No: 97117-177
Subject: HT 230 Lower Shock Absorber Bracket
Date: February – 2009 Revision D

| | | WELDING INST. FOR HT230 SHOCK CLEVIS | | 49441-249 | |

Figure 1.

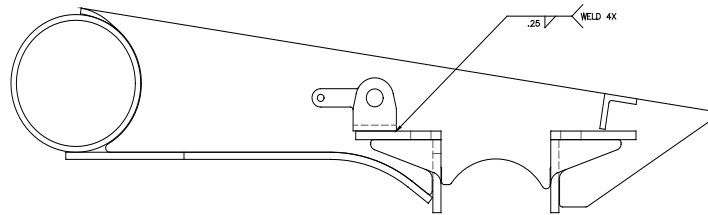
Instances of a cracked weld around the trailing arm shock absorber bracket have been reported. The clevis can be effectively replaced if the lower shock absorber clevis becomes detached or a crack is detected at the connection to the trailing arm (see Figure 1).

Kit Part number 98544-021 is available to complete the repair. The kit contains a replacement clevis, shock absorber bolt and reinforcement gusset block. Where the weld retaining the original clevis has cracked, or the clevis has become detached, grind off the remaining weld. It is paramount that cracks or damage to the trailer arm plate are ground, welded and the area is smooth and flat prior to the new clevis being fitted.

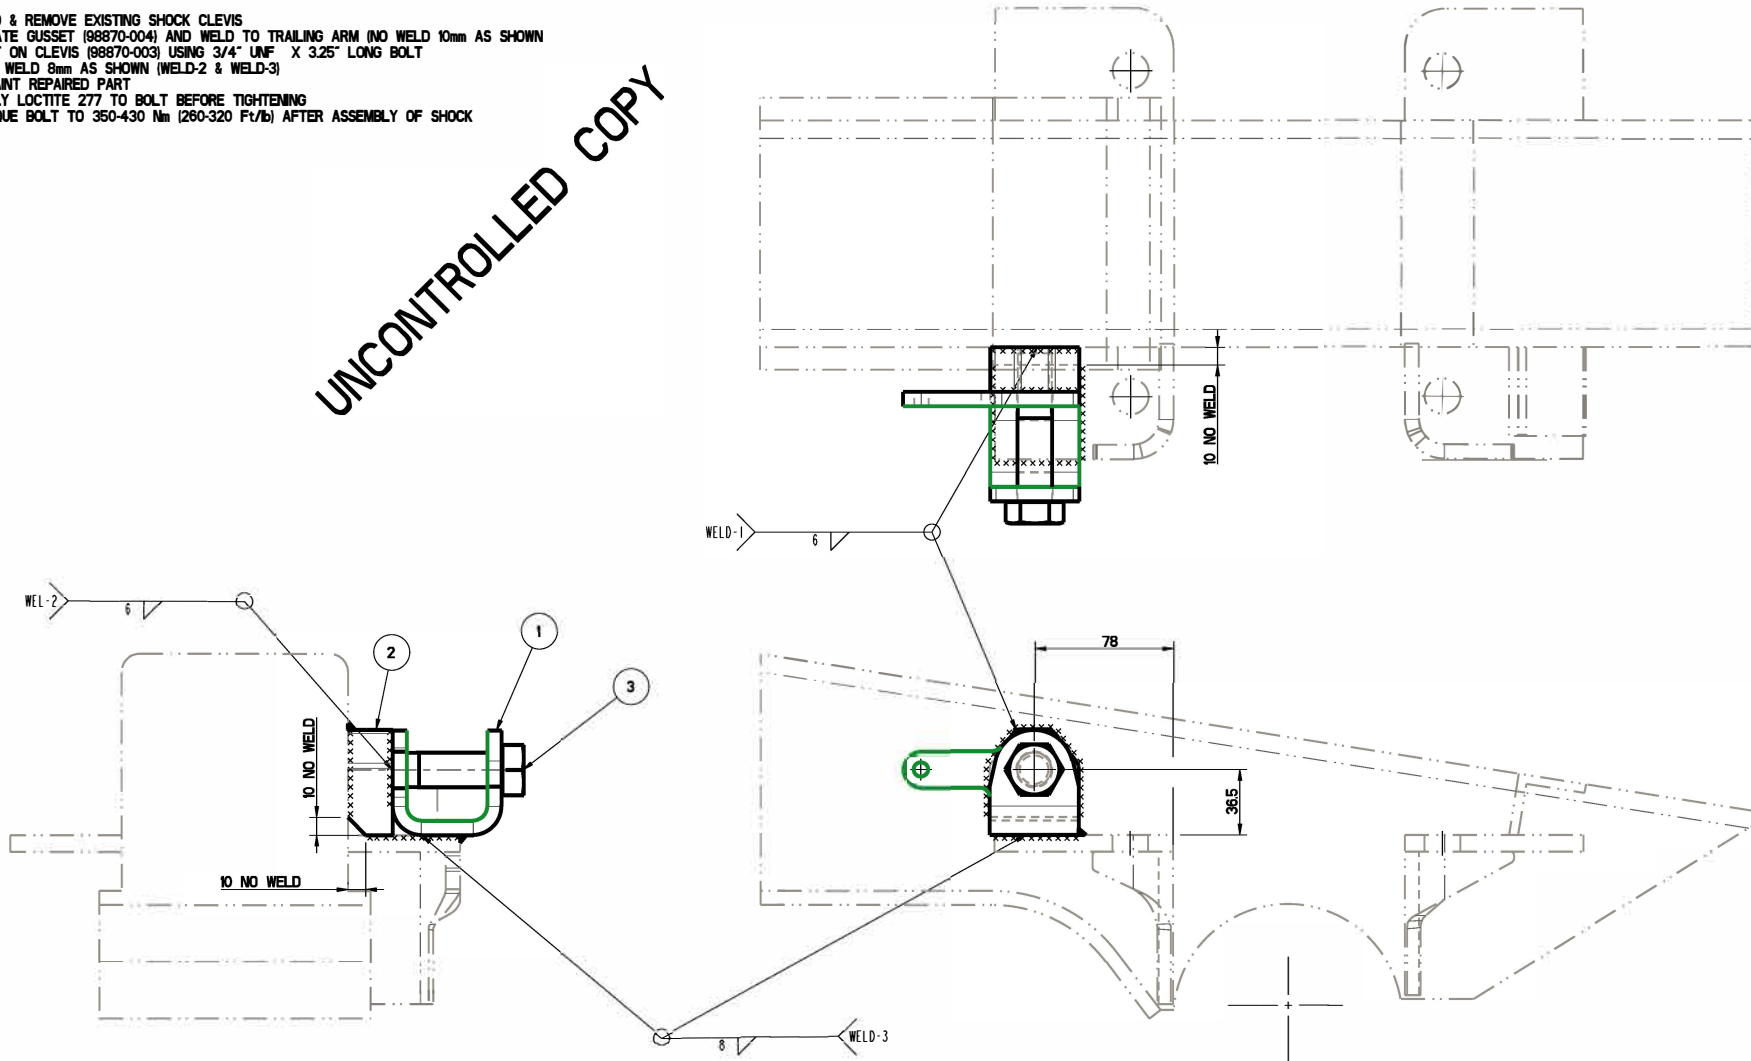
| REVISIONS 03 98870-003 & 004 WERE 98873-003 & 004 7756 02 LOCTITE NOTE ADDED FOR BOLT 7145 01 Release 7008 | 01-10991 01-10991 01-10991 01-10991 | Revision Record 01-10991 01-10991 01-10991 01-10991 | 01-10991 01-10991 01-10991 01-10991 | 01-10991 01-10991 01-10991 01-10991 | 01-10991 01-10991 01-10991 01-10991 |

- 1) GRIND & REMOVE EXISTING SHOCK CLEVIS
- 2) LOCATE GUSSET (98870-004) AND WELD TO TRAILING ARM (NO WELD 10mm AS SHOWN)
- 3) BOLT ON CLEVIS (98870-003) USING 3/4" UNF X 3.25" LONG BOLT
- 4) NOW WELD 8mm AS SHOWN (WELD-2 & WELD-3)
- 5) REPAINT REPAIRED PART
- 6) APPLY LOCTITE 277 TO BOLT BEFORE TIGHTENING
- 7) TORQUE BOLT TO 350-430 Nm (260-320 Ft/Lb) AFTER ASSEMBLY OF SHOCK
